Botley West Solar Farm

Applicant's Responses to Local Impact Reports Submitted
at Deadline 1

PINS Ref: EN010147

Document Ref: EN010147/APP/12.3

P:\eur-mpfs-02.eur.rpsgroup.com\Projects\12426 Proposed DCO Scale Solar Development 860mw\TechDrawings\12426-0233-02.aprx

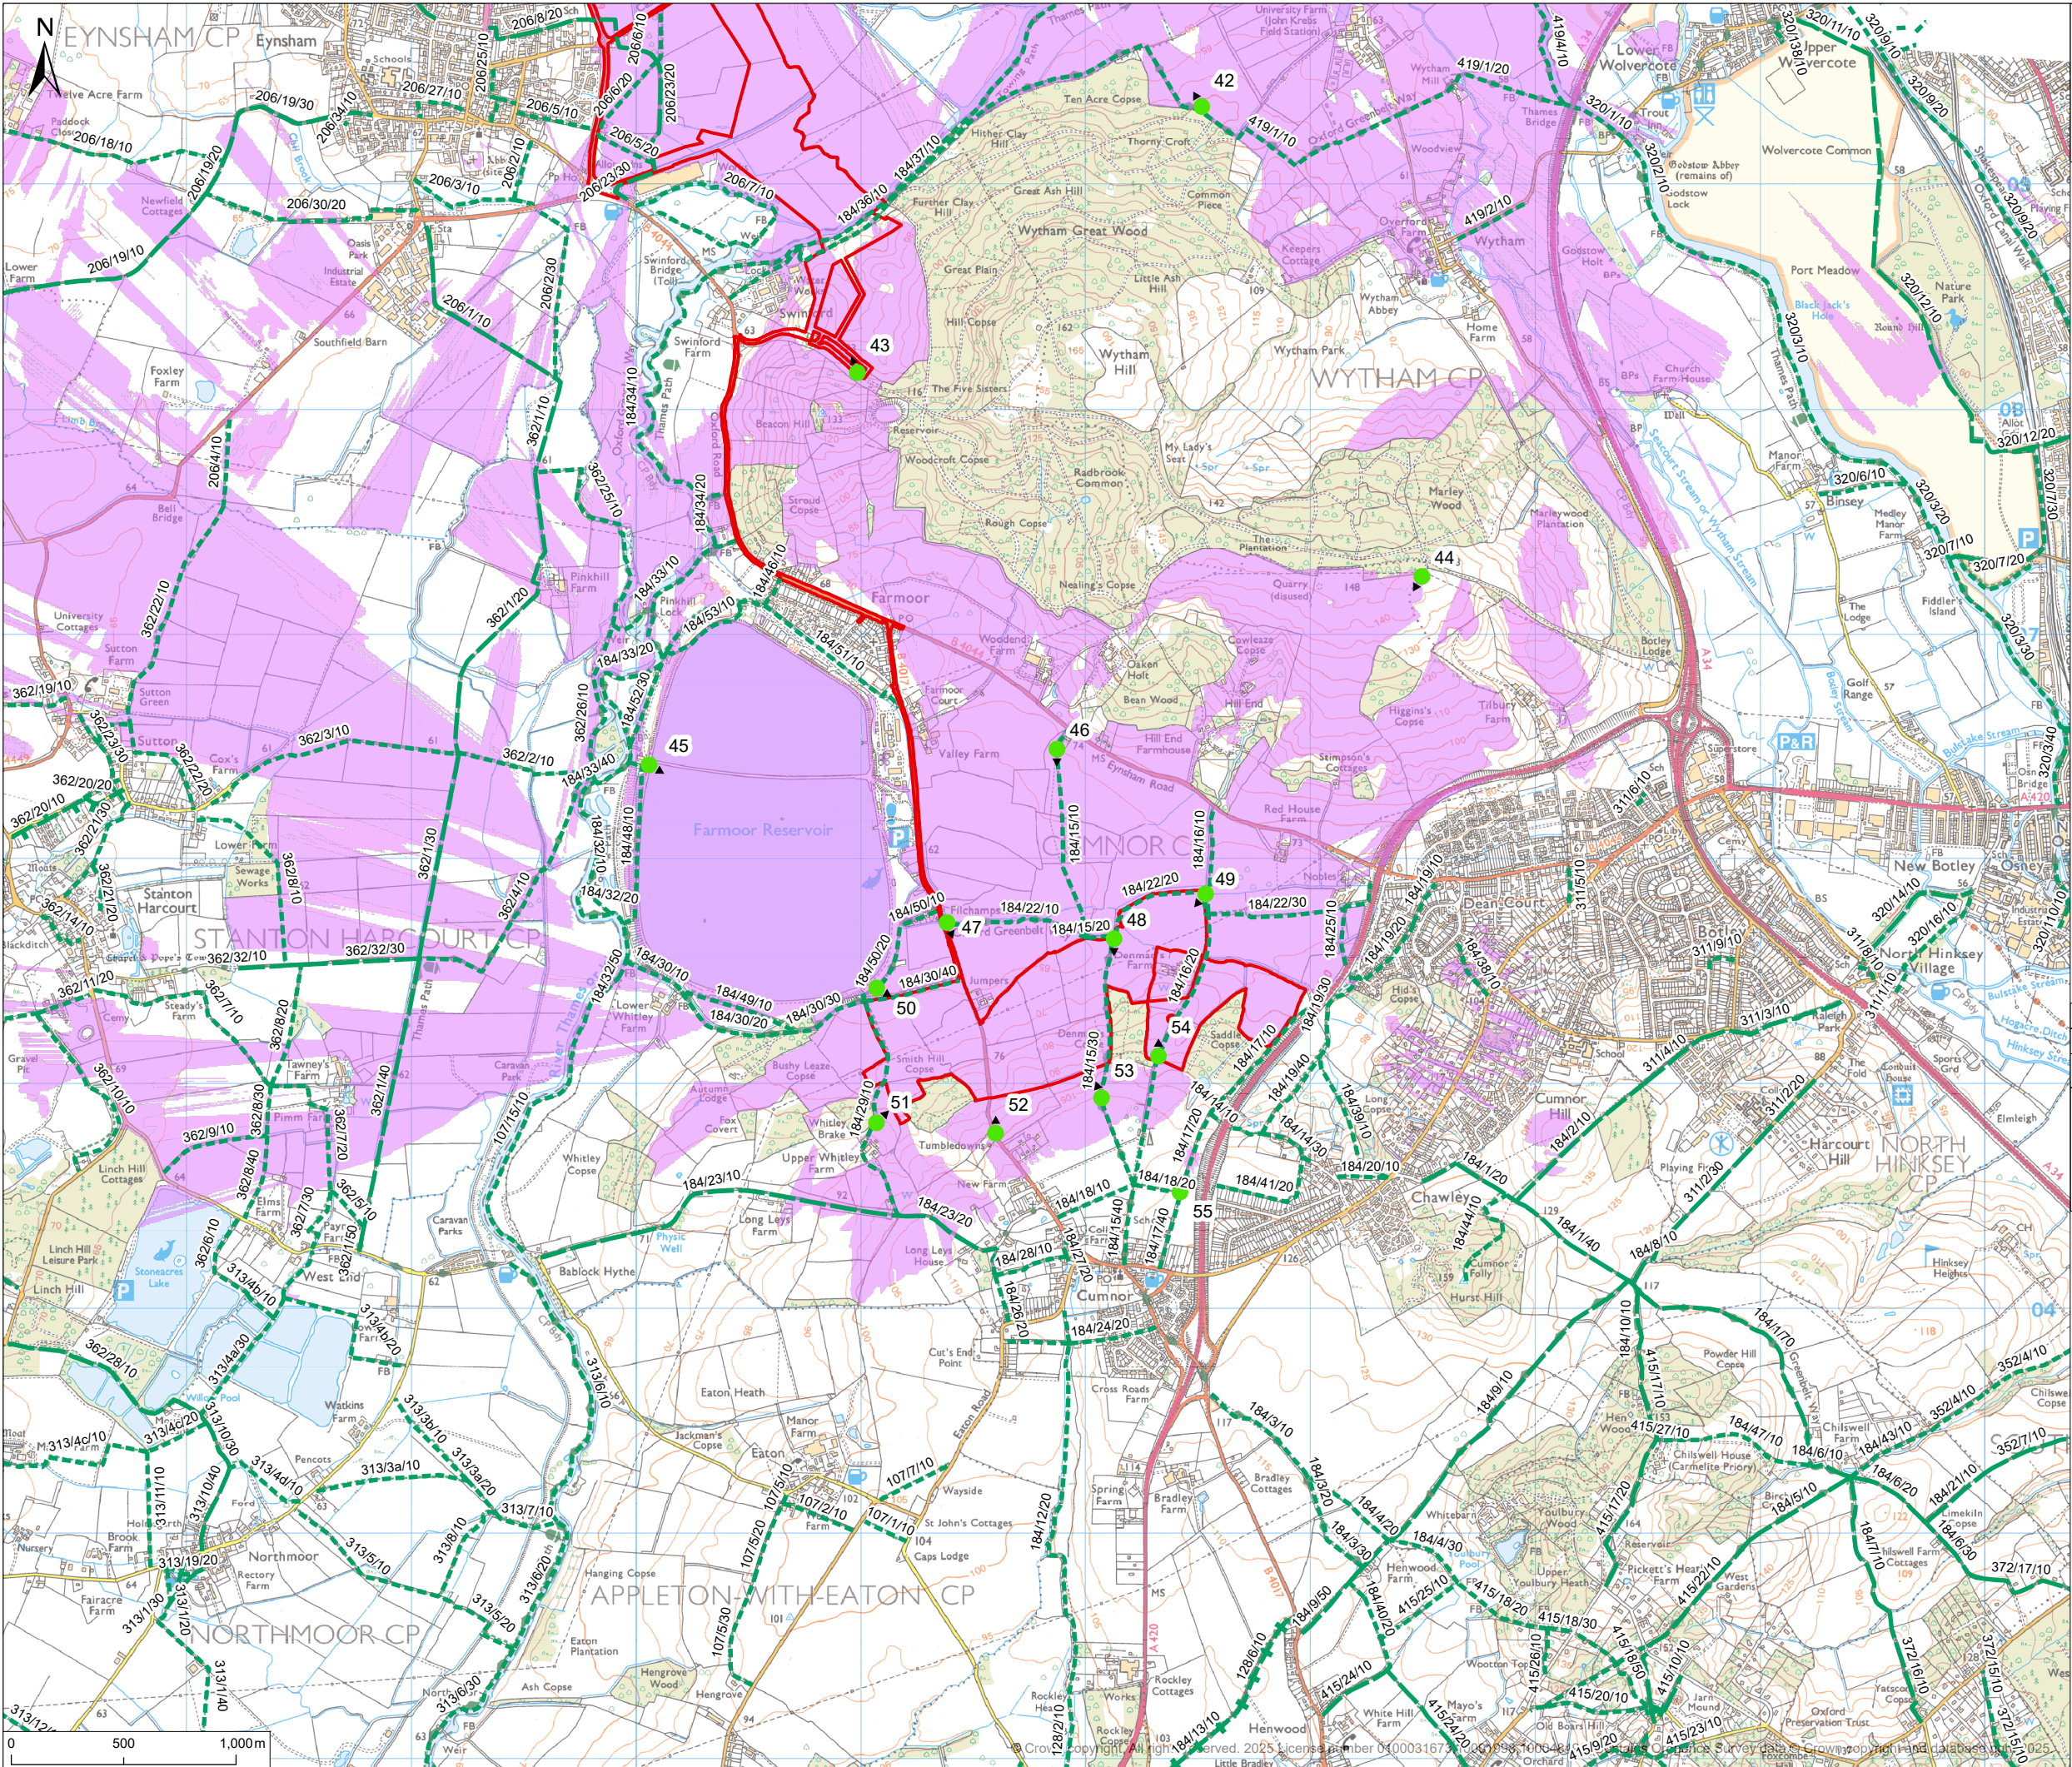
| Name | Comment | Applicant's Response | Issues |
|--|---|--|------------------------------|
| Joint Local Impact Report of CDC, VWHD, WODC and OCC | 7.3.56 The LVIA information is not easily accessible, and it would be helpful to have a plan that includes the Masterplan Layout, Viewpoint locations and the PRoW clearly marked and numbered, to help with the understanding of the submitted visualisations | Figures showing the ZTV, the labelled PRoW and the viewpoints on 1:50,000 OS mapping are provided with this response (appended as Figures 12.3.1 to 12.3.3 of this document). | Landscape and Visual Impacts |
